S.H.(I.C.H.) 345 SEC. GR
MUSKINGUM COUNTY

EXPLANATORY NOTE

Revised Plan of South Abutment
DRY RIFFLE RUN BRIDGE
STATION 53+15
CONCRETE BEAM BRIDGE
50' SPAN 19' HEIGHT 30' ROADWAY
S.H.(I.C.H.) 345 SECTION GR
MUSKINGUM COUNTY
STATE OF OHIO
SEPT. 1929 BUREAU OF BRIDGES
Checked by L.W.C. 10-24-29

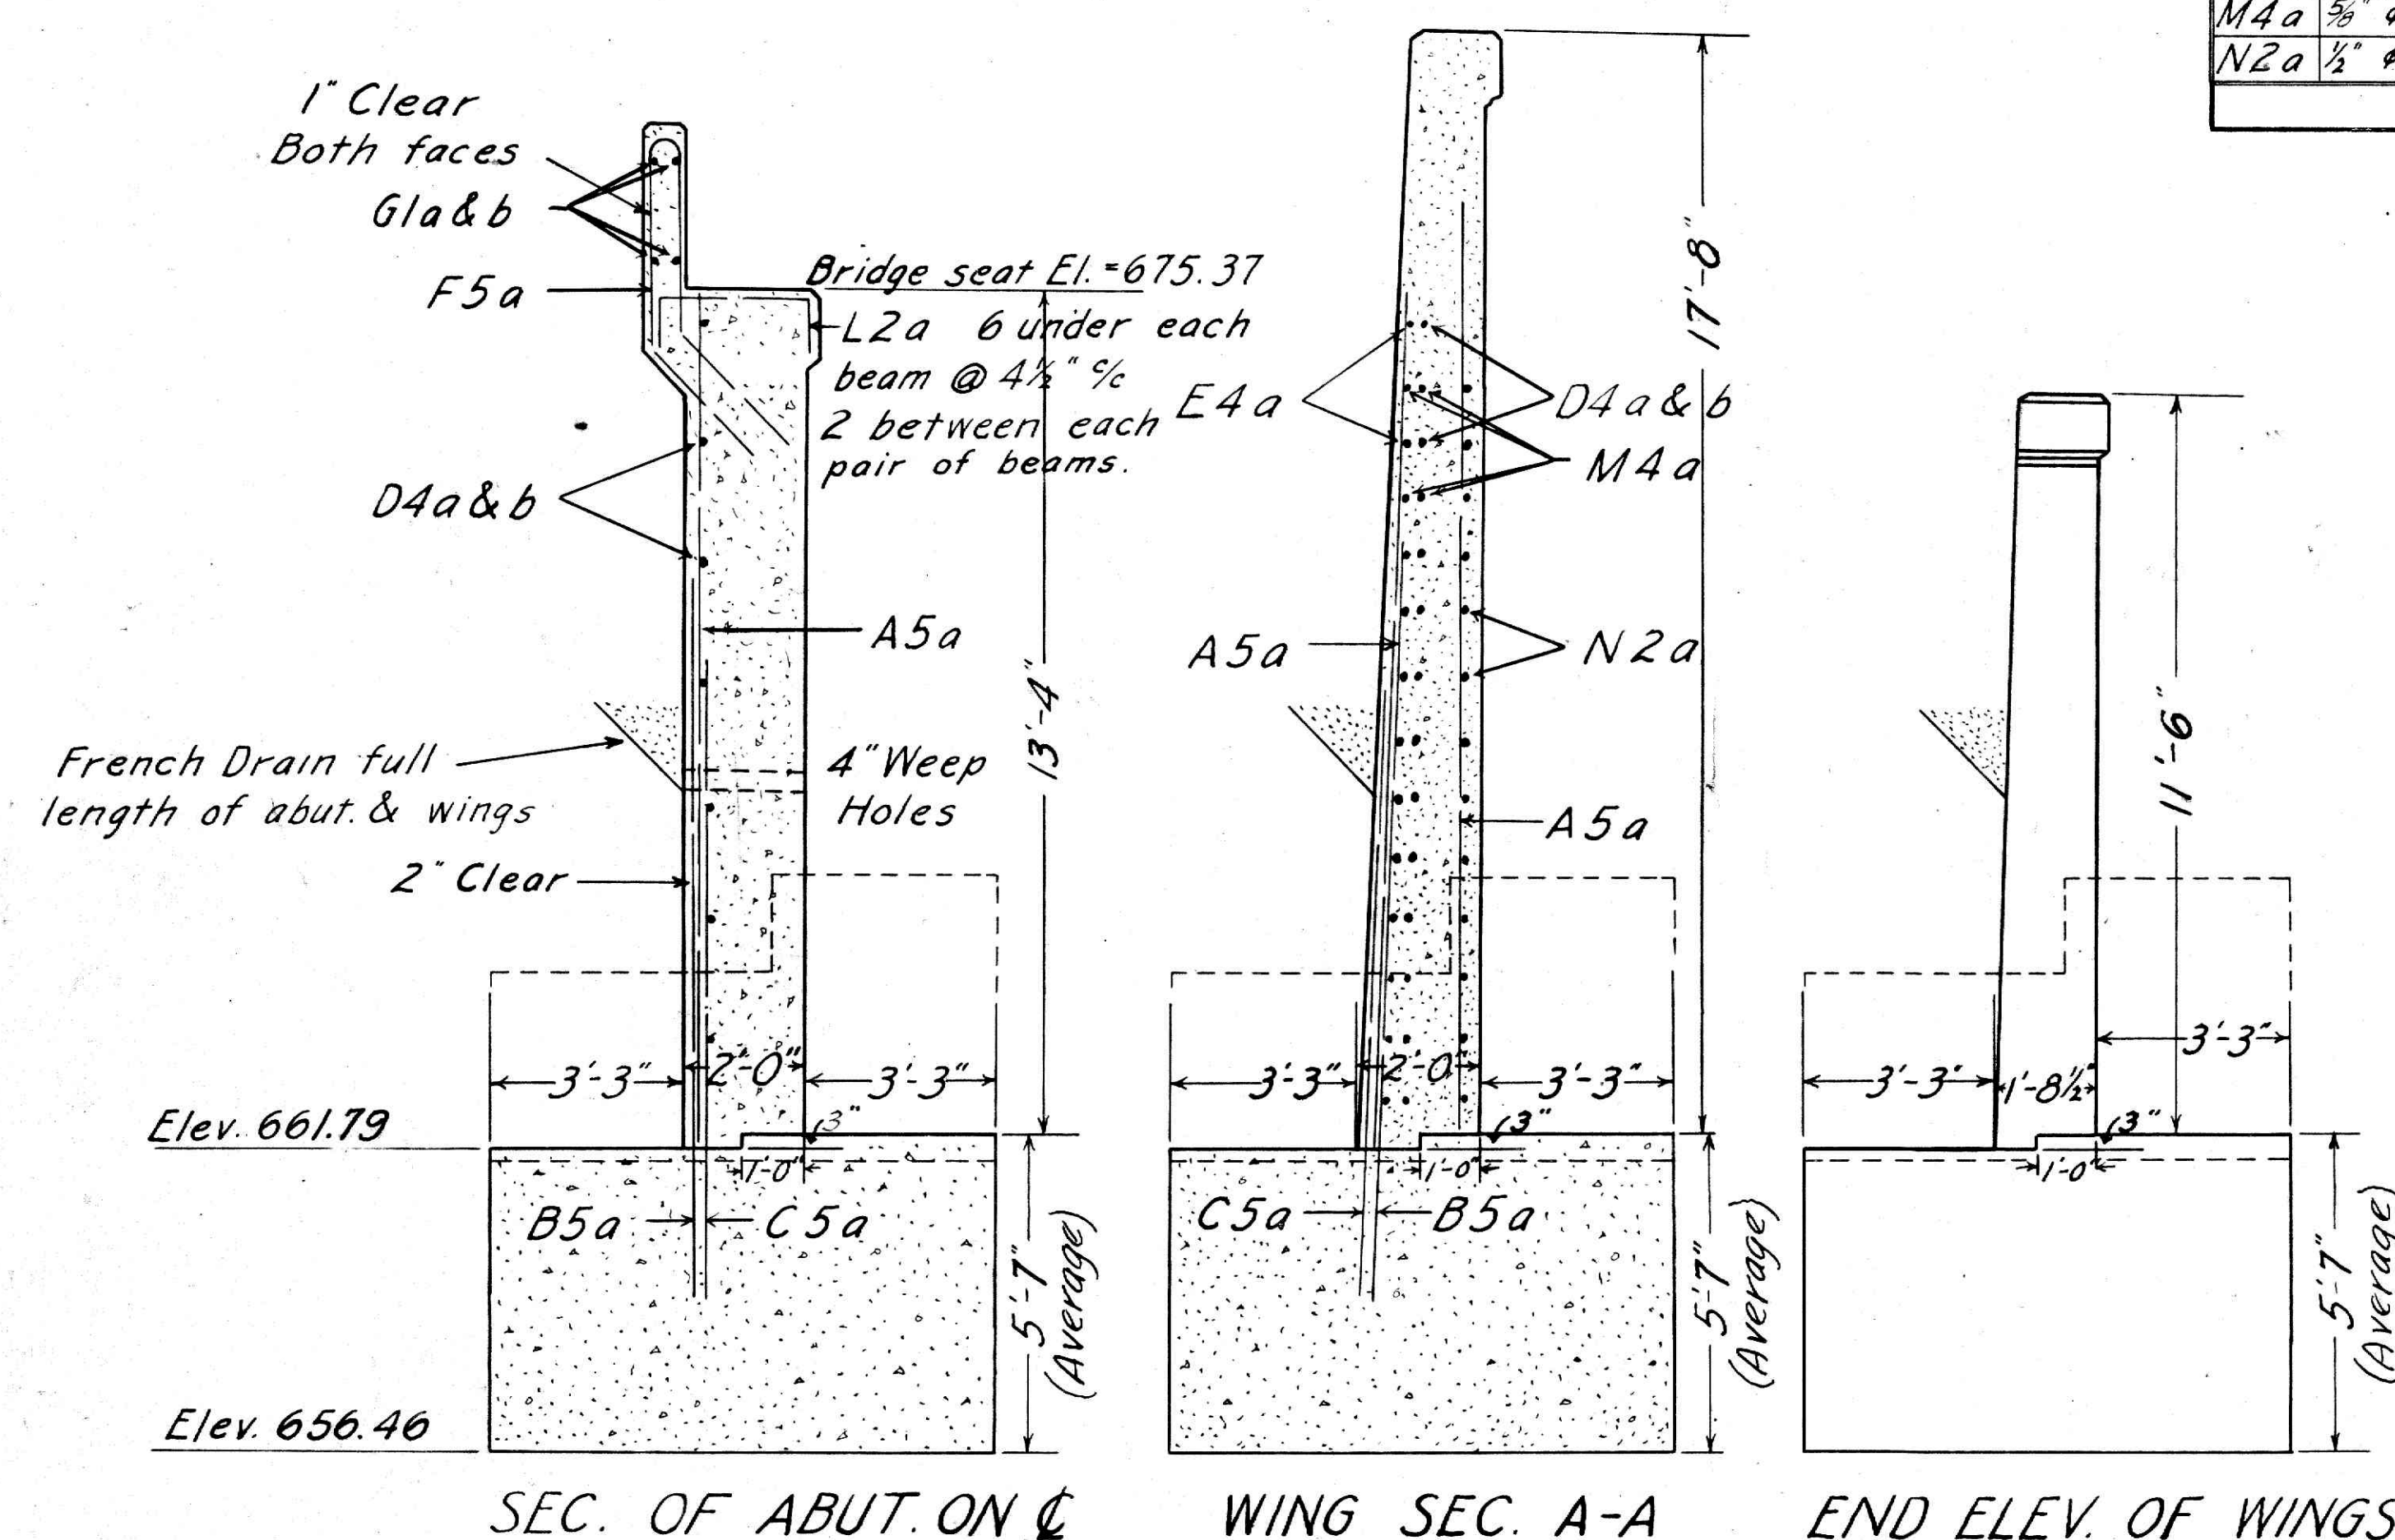
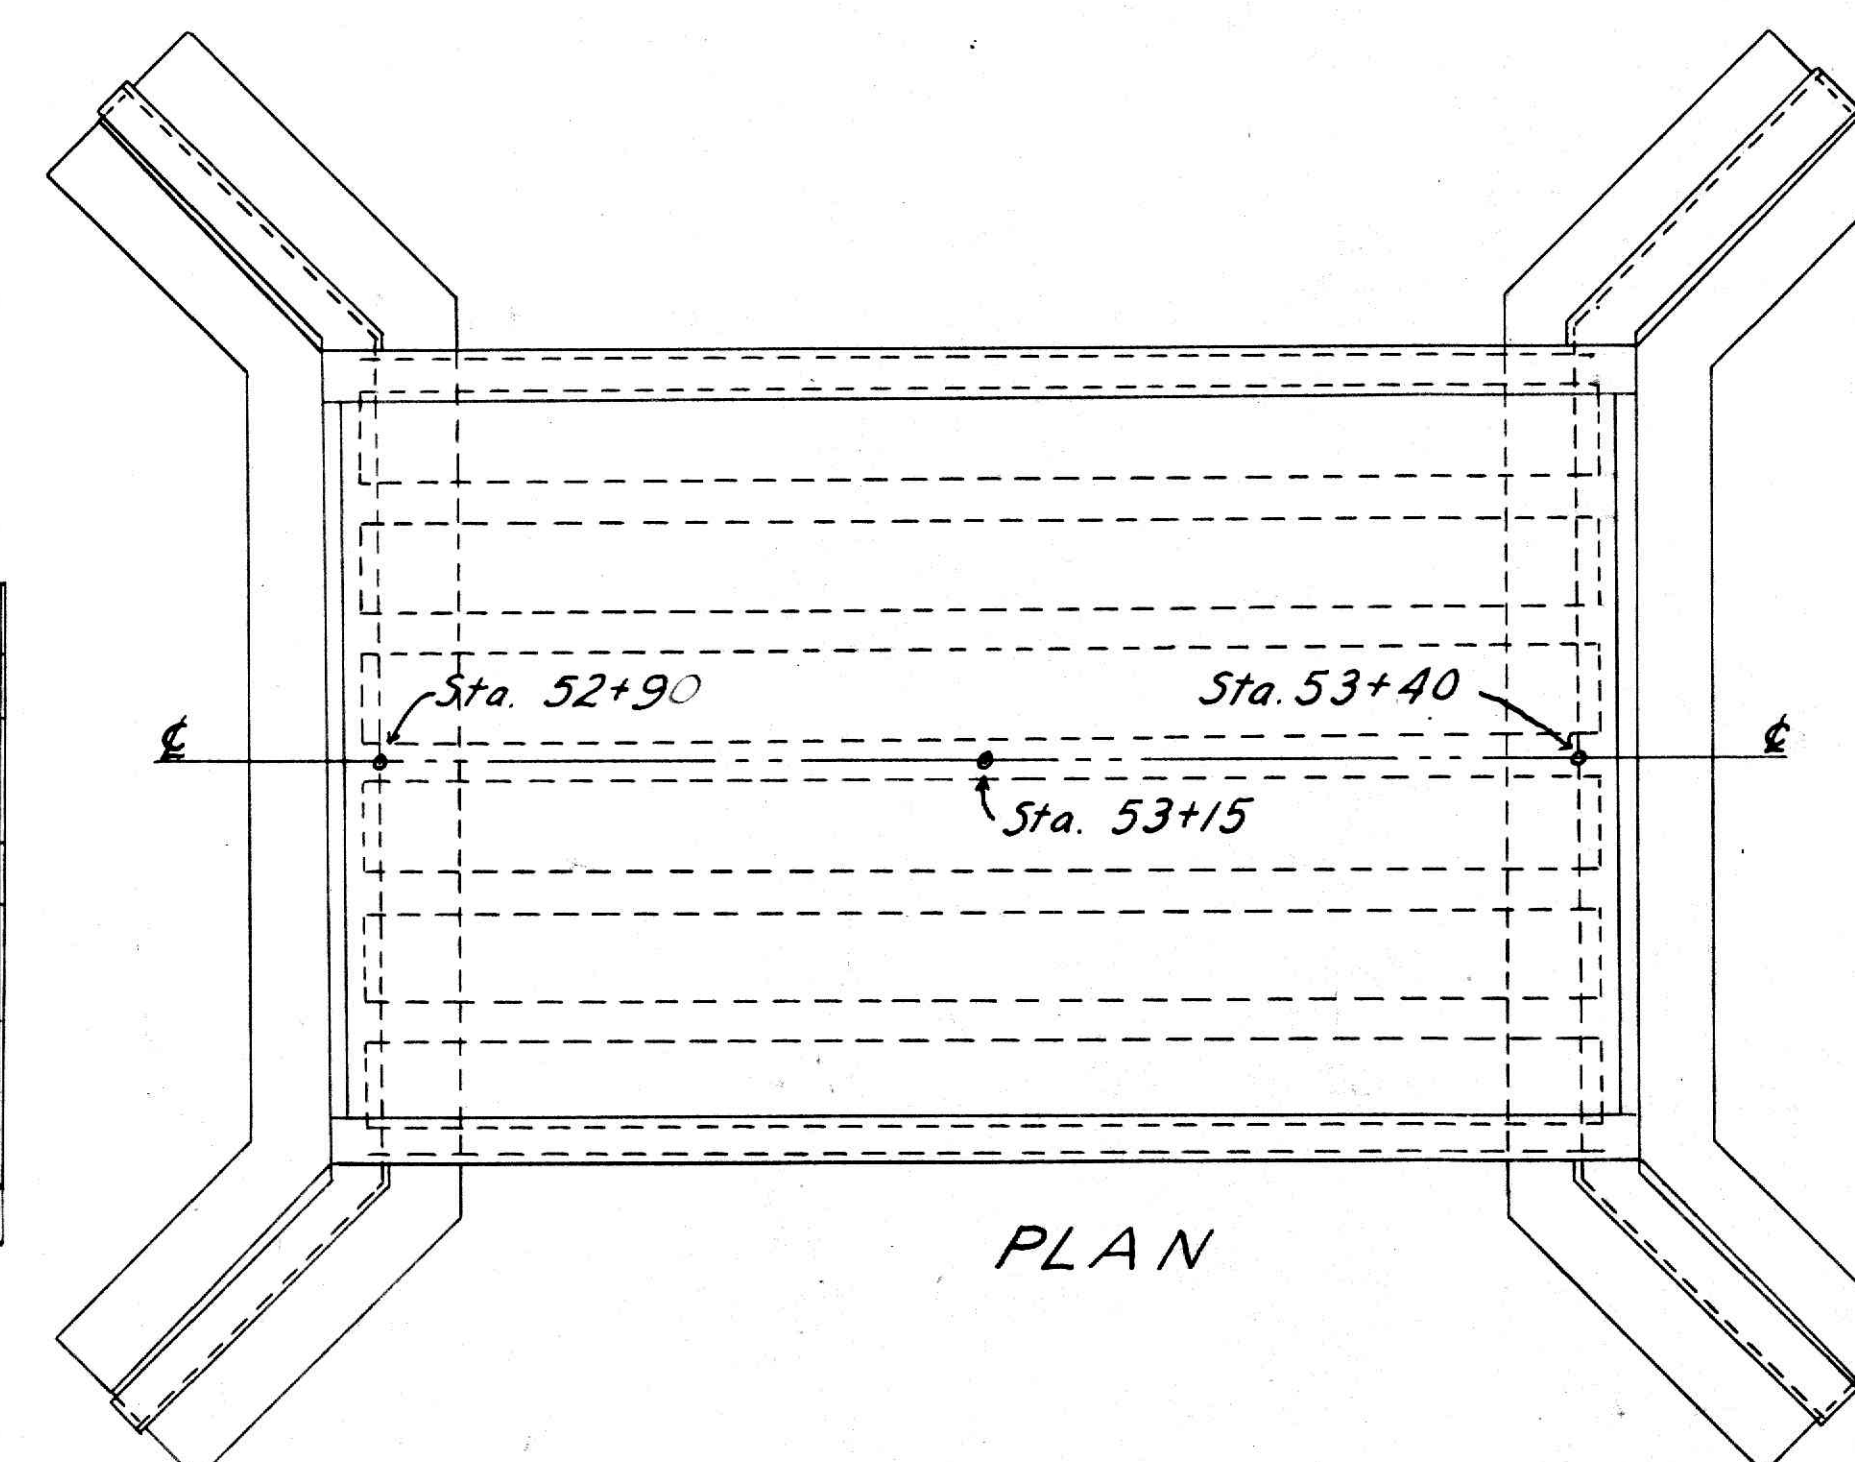
This sheet is supplementary to sheet No. 14 of the original plans. The north abutment was built according to the original plans. The south abutment was built as shown on this sheet; the design was changed because rock was encountered at approx. Elev. 658.0, thus making it impossible to drive piles and making it necessary to deepen the footing. Approx. 40 Cu. Yds. of loose and irregular rock were removed to obtain a firm and even foundation.

Note: Broken line shows footer as originally planned.

REVISED PLAN	QUANTITIES
Exc. rock	40 Cu. Yds. (New Item)
Exc. wet	336 "
Conc. 1-6 1/2 (footing)	183.4 "
Conc. 1-6 1/2 (walls)	116.1 "
Reinf Steel	8271 lbs.
Lump-Cofferdam & pumping	\$200.00 (Additional)
Exc. Dry	360 Cu. Yds.
Deduction from original quantities 1430 lin. ft. of piling.
